Office for
Nuclear Regulation

**Return to service safety case for Reactor 4 following core inspection results in 2018
(NP/SC 7785),
Graphite structural integrity assessment**

Assessment Report ONR-OFD-AR-19-007
Revision 1
August 2019

Figure 2: Potential Multiply-Cracked (Quadruple-Cracked) Fuel Brick.

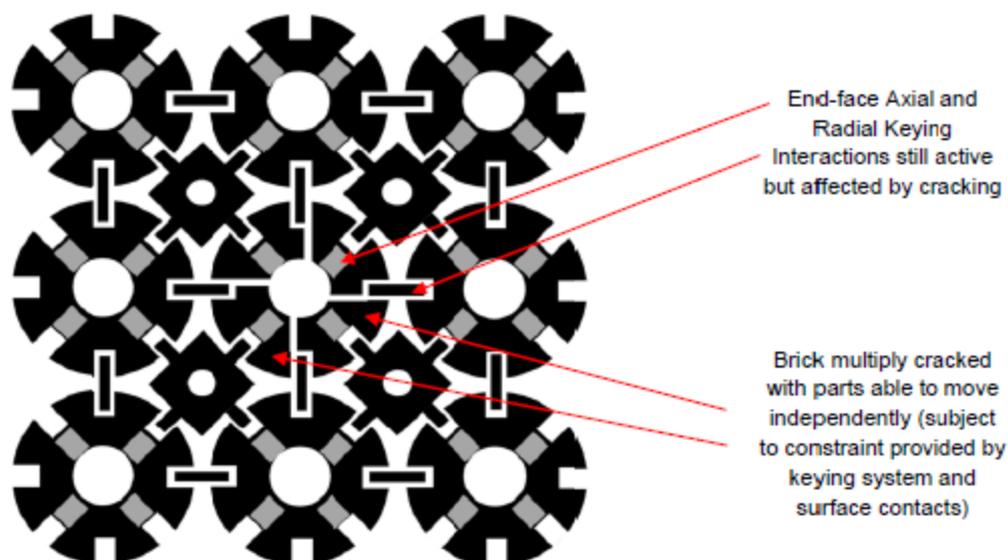
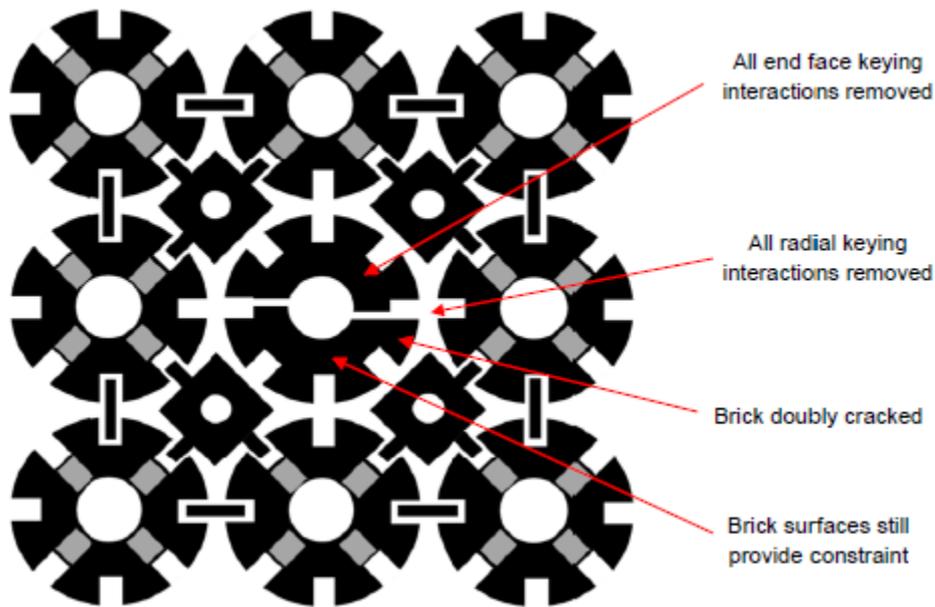
- 145 Figure 2 illustrates an idealisation of an MCB. It indicates the MCB in the centre which is separated in to four axial pieces at the “loose” keys (fuel brick to fuel brick), but could equally be considered to be cracked at the “integral” keys 45° around (fuel brick to interstitial brick) or a mixture of both. Figure 3 illustrates the proposed proxy-MCB representation.

- 146 Figure 2 illustrates the radial and end-face keys still being in place compared to the proxy-MCB in Figure 3, which removes them. Whilst this may seem a grossly conservative implementation in terms of the potential for channel distortion, what would happen in reality is uncertain and it would seem a sensible approach to remove the key/keyway interactions entirely to erode as much of the keying system as possible. This may come with disadvantages, for instance by removing the integral keys the associated interstitial brick is no longer able to directly influence the position of the quarter piece of the MCB. This may be conservative for the seismic event where the absence of integral keys means the interstitial channels can distort more due to the seismic oscillation. But, in the at-power or off-load state, the integral key could be utilised by crack opening in neighbouring fuel bricks to pull the quarter piece of MCB away from the rest and create space for key disengagement and potentially fuel channel blockage from dislodged keys. Conversely, crack opening in neighbouring bricks might use the integral key to push the quarter piece into the fuel channel creating a ledging/snagging risk to the fuel. NGL has made its view clear in Reference 58, pointing out that the least reliable outcome from the use of proxy-MCBs is for the

- 150 I am therefore content to accept the proxy-MCB implementation in the context of NP/SC 7785. I must note that NGL has implemented the proxy-MCB methodology as a time saving measure whilst a more detail methodology is developed. Whilst I am content with the proxy-MCB implementation, my view is that improvements in the methodology would benefit the safety case and are entirely achievable so I see no reason why they should not be provided in future safety cases.

Recommendation 1: *Before any further permission for operation of HNB R4 is requested, NGL should set out a plan to replace the implementation of proxy-MCBs in the whole core models with a full MCB representation.*

Figure 4: Control rod channel peak DUs for normal operation, SCBs and DCBs only.
 (Reproduced from Reference 31)

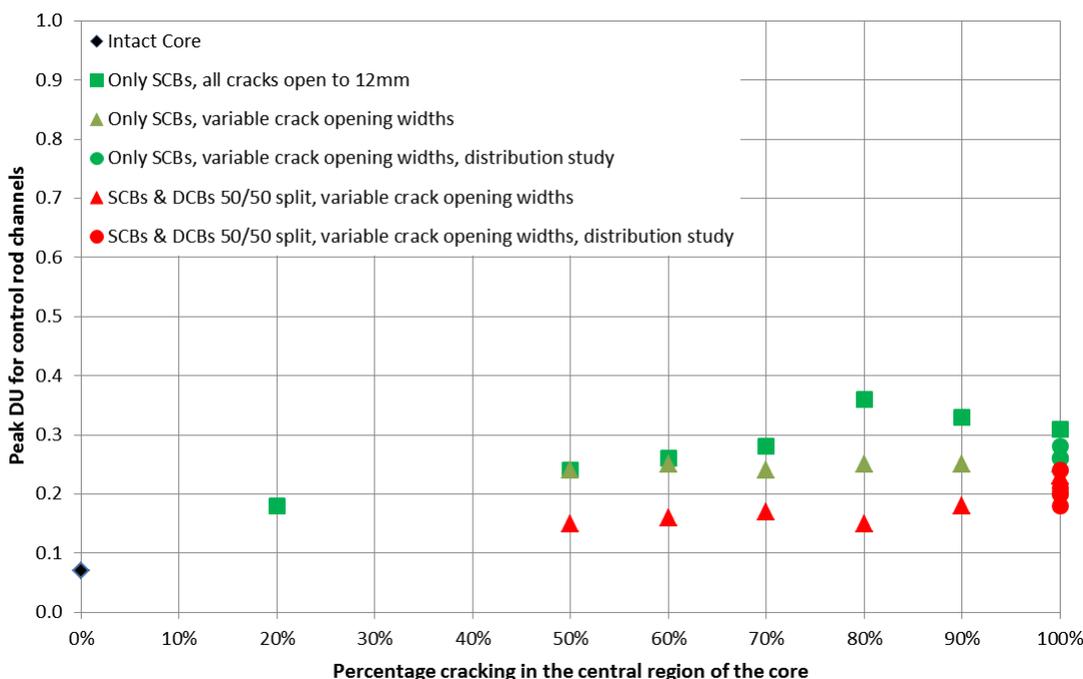
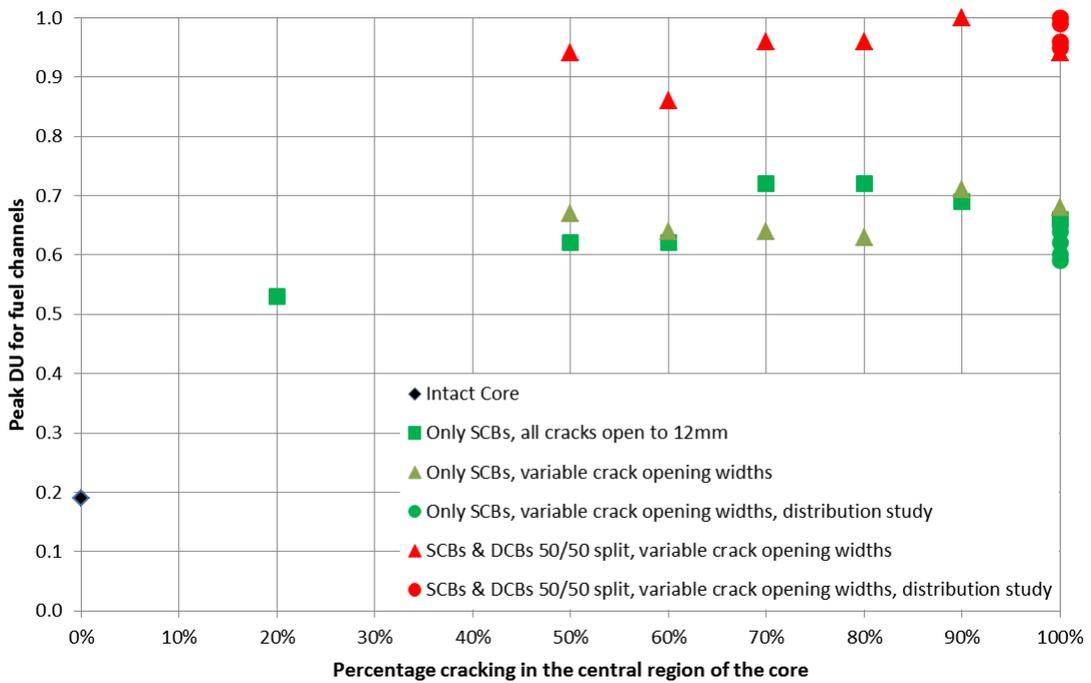
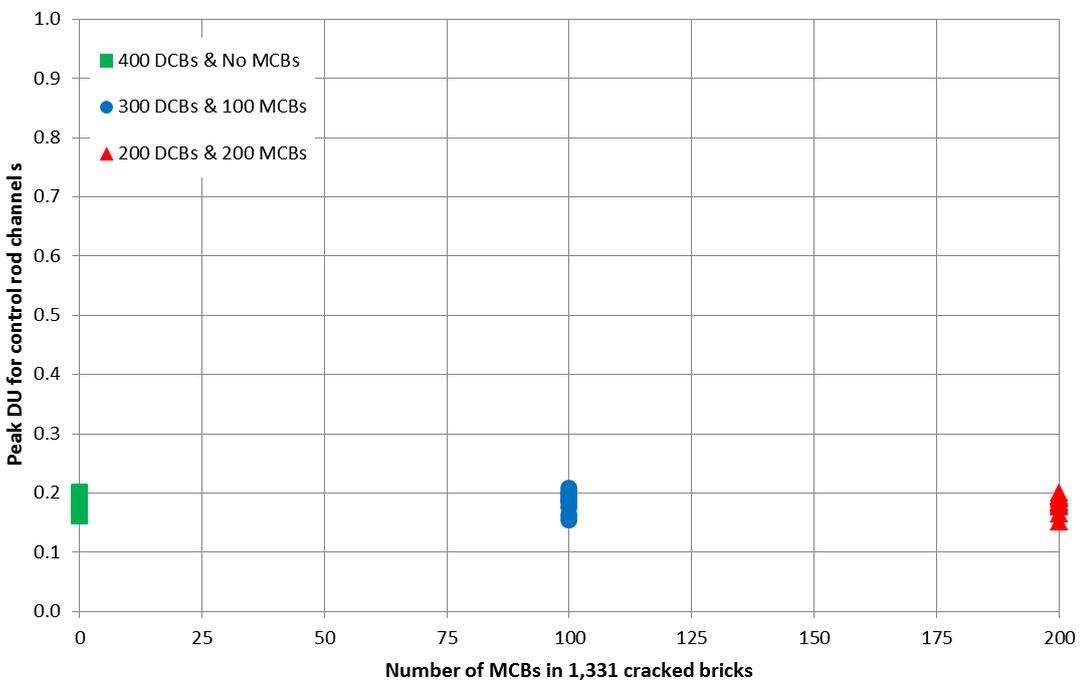
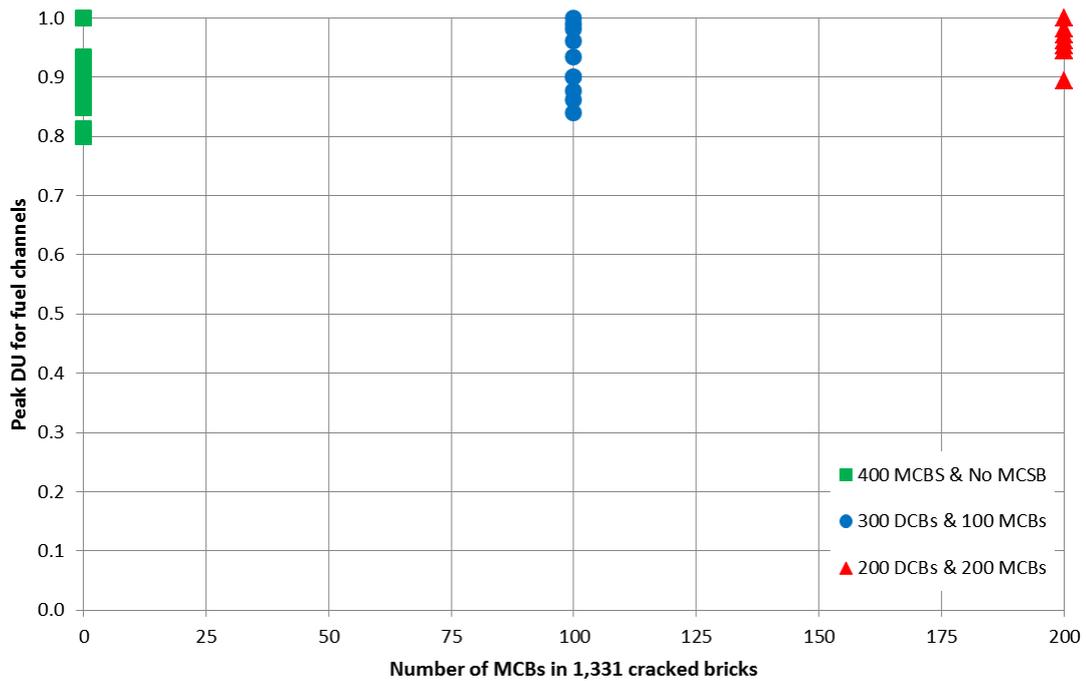
- 164 In my view the primary conclusions to draw from Figures 4 to 7 are: that control rod channel distortion is low and does not substantially change once the number of cracked bricks has exceeded a small quantity; and that DCBs can create a step change in the peak fuel channel distortion. I consider the effect of DCBs on fuel channel distortions below in Section 4.5.6.

165 The apparent invariance of the peak control rod channel distortion appears physically reasonable because the results are associated with the worst channel distortion identified for that configuration of cracking in the core. This is likely to be more influenced by the particular local configuration of cracking around a channel than the widespread distribution of cracking across the core. This makes the use of the CEDTL potentially misleading because the purpose of the CEDTL is to show margin exists beyond the OA in terms of the numbers of cracked bricks. The low sensitivity of the peak channel distortion to the numbers of cracked bricks was not established when the principle of the OA and CEDTL was defined, but was instead dealt with by NGL via other sensitivity studies. For instance, the channel distortion may also be dependent on the brick-to-brick clearances as well as the clearances and load capacities of the keying system, which will change with core age. These have though been studied by NGL in the supporting references and show little variation to core age.

167 NGL’s work, summarised in Reference 30, 31 and 35, shows that the peak fuel channel distortion margins in a core with cracked bricks are significantly degraded from the intact core condition (see also Figure 5). However, the work has also shown that once a certain amount of brick cracking has occurred, the margins do not substantially change over the range of cracked brick numbers evaluated by the work (Figure 5 for example). For instance, the peak DU for an intact core is predicted to be small, about 0.2, the introduction of SCBs with significant crack opening widths raises the DU into the region of 0.5 to 0.7. Exchanging some of those SCBs for DCBs further elevates the DU to 1.

Figure 8: DU variation for different levels of cracking and random distributions. (Taken from Reference 67, at 30% there are 64 different random distributions evaluated, at all other percentages there are 10.)

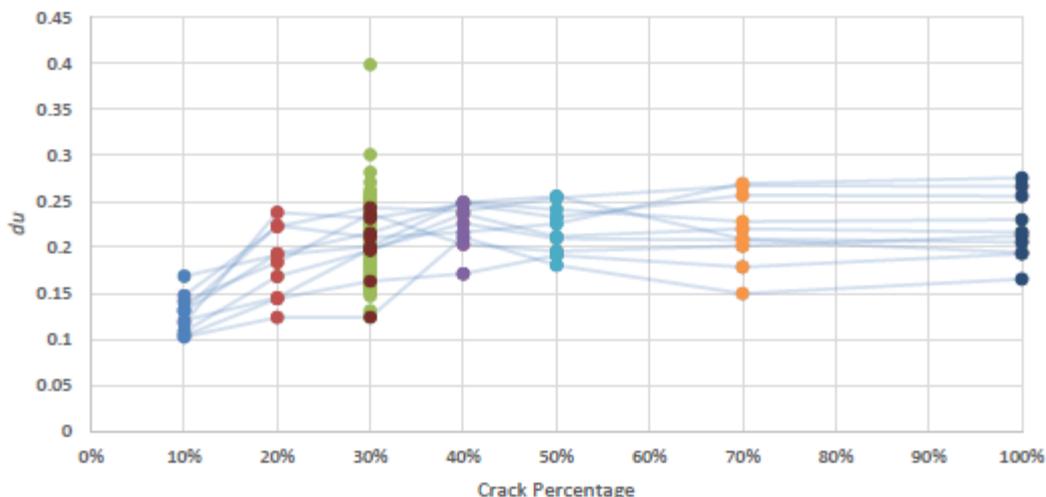
183 In my view, these low control rod channel distortions are necessary to mitigate the real possibility that larger distortions could be achieved by the same level of cracking but occurring in a more onerous spatial distribution. Until recently no such configuration had been identified, but a sensitivity study (Reference 67) consisting of 64 different configurations of approximately 525 (~30%) cracked fuel bricks identified one such configuration, see Figure 8 below. The peak control rod channel DUs of 63 of the 64 configurations were tightly packed in the range of 0.1 to 0.3, but one of the 64 configurations returned a peak DU of 0.4 (the green dots in Figure 8).

- 184 Although a DU of 0.4 is still low, it is singularly separate from the others and illustrates the potential for larger distortions to exist outside the main spread of results. NGL investigated this and found that the DU of 0.4 was entirely caused by a particular clustering of only 4 cracked bricks. In other words, even if no other bricks in the core were cracked, this 4-brick cluster would still return a DU of 0.4. I subsequently asked NGL to explain its cause. NGL provided further explanation that it was caused by a local clustering of 4 SCBs, with large crack openings, situated around a control rod channel. The SCB crack opening widths were large, i.e. 16mm to 22mm and the random orientation of the cracks was such that the crack opening was able to generate significant space around that control rod channel. The fact that this cluster occurred once in a set of 64 randomly generated distributions or in any of the other configurations with different numbers of cracked bricks (of which there are 60) is an indication to its likelihood, but this does not mean it can be discounted.

- 185 It is important however, not to focus on the specific 4-brick cluster identified in Figure 8, but more generally on the fact that such 'outlier' configurations could occur in normal operation. However, specifically arranged and advanced levels of damage are also necessary. For instance it is possible that more severe crack morphologies and clustering exist that are less likely than the 4-brick outlier but which are still likely enough to need consideration. It is also possible more severe clusters than the 4-brick outlier might allow an outlier at smaller crack opening widths. I acknowledge that this is speculation but I must also state that no work has been done to discount such possibilities. In my view then, when considering a requirement that all the control rods must be able to enter the core all of the time, these variations in the peak channel distortion must be considered. The damage tolerance assessment (DTA) methodology used by NGL generally evaluates only 10 randomly generated crack configurations at each cracking level. The distribution of channel distortions can therefore allow determination of a most likely minimum distortion value and a distribution thereof, but with only limited precision. It follows then that the safety margins on the peak channel distortions must be sufficient to accommodate the potential for outlier distortions. Even with the 4-brick outlier, the DU was 0.4, in other words, the distortion would have to be two and a half times worse. In my view, it is reasonable to expect that to obtain substantially larger distortions than the outlier, substantially greater damage than the OA and CEDTL would be required. I therefore conclude that the low distortions allow a safety margin for unimpeded control rod entry to be maintained even when the possibility of more severe, but less likely, distortions are considered.

Figure 9: Control rod channel peak DUs for seismic, SCBs and DCBs only.
 (Reproduced from References 73 and 74)

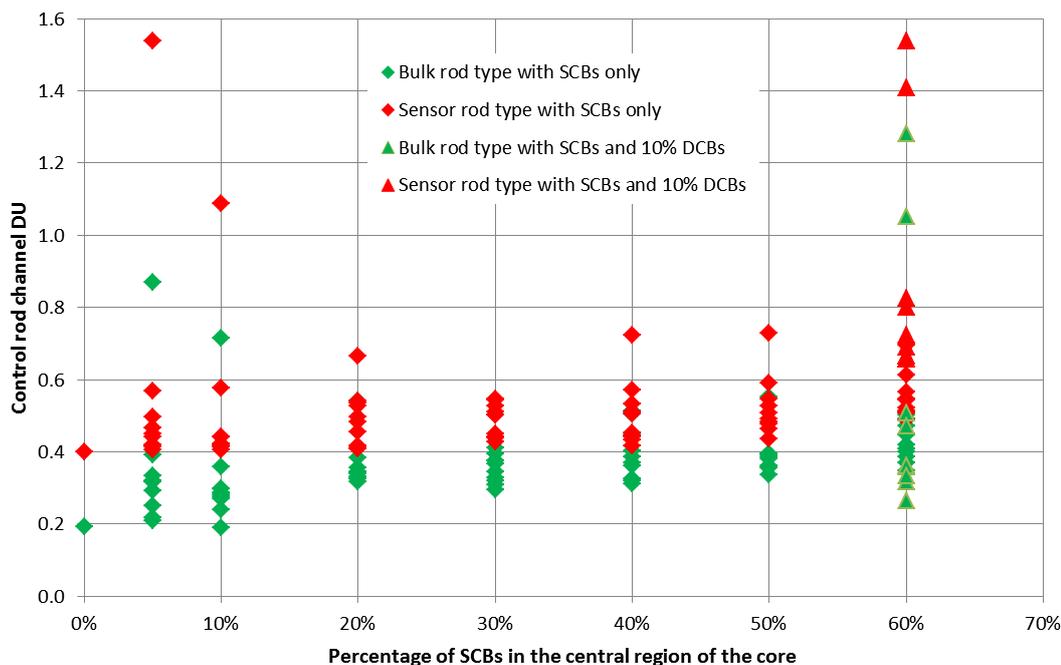
- 204 NGL then introduced 10% (~200) DCBs to the seismic case and again found DU values exceeding 1 (see Figure 9 at 60%), but did not commit to making arguments whether they were non-physical or otherwise. Instead, NGL assumed the DU values greater than 1 were real and relied on arguments that the seismic event itself was grossly conservative. At the time, NGL was reworking the seismic input to the graphite core on the basis that significant conservatism had been identified in the translation of the ground motion to the graphite core via the building that houses it, the PCPV.

209 It is also important to note that the peak channel distortion DU values for the legacy model (see Figure 9) are for the most part less than 1. This further emphasises the causes of those few DU values that exceeded 1 to be associated with particular local configurations. Given that the revised model has shown tolerance with substantial numbers of DCBs, I conclude that particular attention must be made to the number of key/keyway interaction overloads and in particular integral key overloads. Focus subsequently shifts to the margin on the keying system forces, which I discuss next.

model case with highest reported DU of 1.54 (see the 60% cracking level in Figure 9); and a case from the updated model with a comparable cracking level and an associated DU of 0.22 (see the 200 DCBs cracking level in Figure 11).

Figure 11: Control rod channel peak DUs for seismic, updated PCPV model.
 (Reproduced from Reference 37)

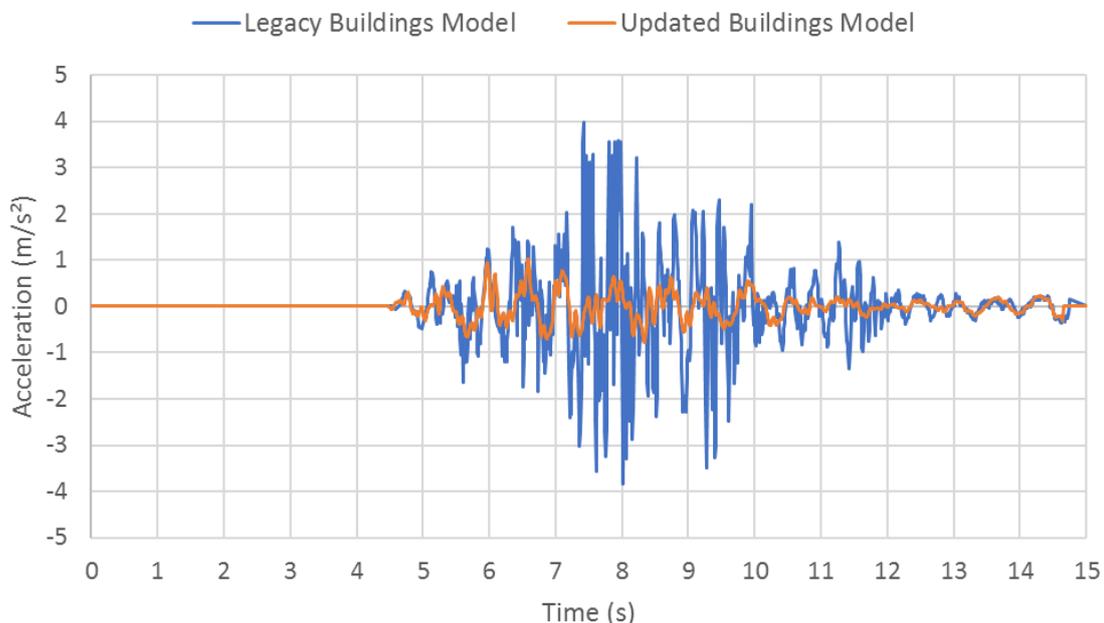
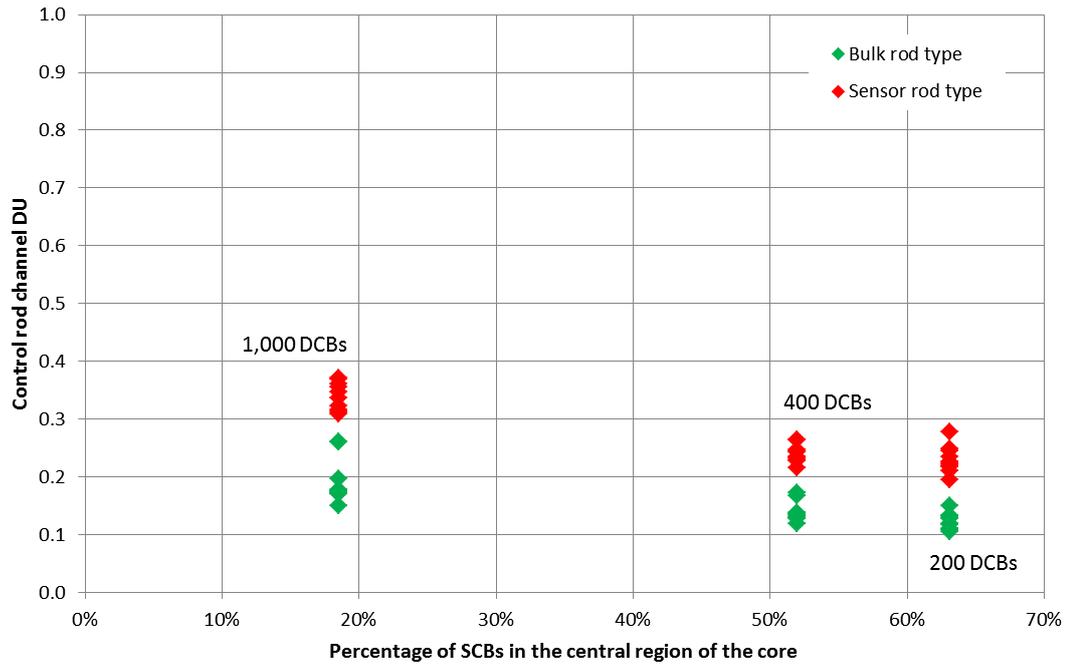
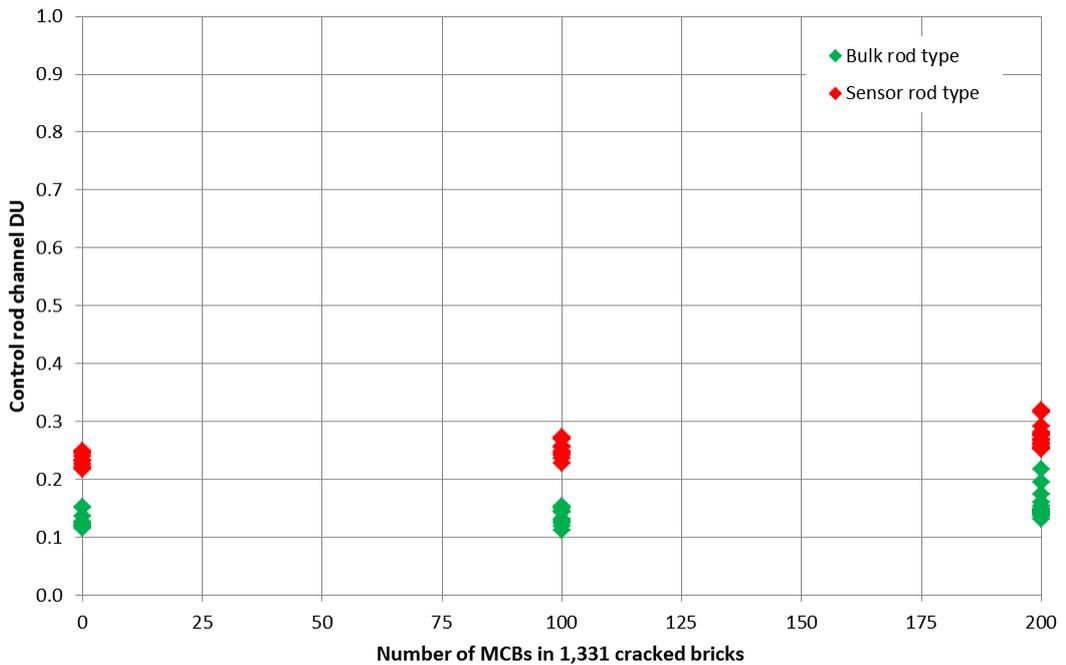
206 It became apparent that demonstration of seismic tolerance could only be achieved with the use of the updated buildings model. This was a significant shift in emphasis for the safety case and ONR determined to assess the updated buildings model. The specialist inspector’s assessment is summarised in Reference 75, and makes a particular recommendation for my assessment, which I consider in Section 4.5.16.

207 NGL claims the cause of the much reduced channel distortions (comparing Figure 11 and 12 with Figure 9) is due to the reduced seismic input causing far fewer failures in the keying system, illustrated by Figure 13 below.

208 It is not surprising that the peak channel distortions would be reduced for such a significant reduction in the severity of the seismic input to the graphite core (Figure 10). However, I accept that fewer removals of key/keyway interactions will also reduce peak channel distortions by maintaining the intended constraints on brick movement and also preventing the kinds of localised failures I have described above in paragraph 201.
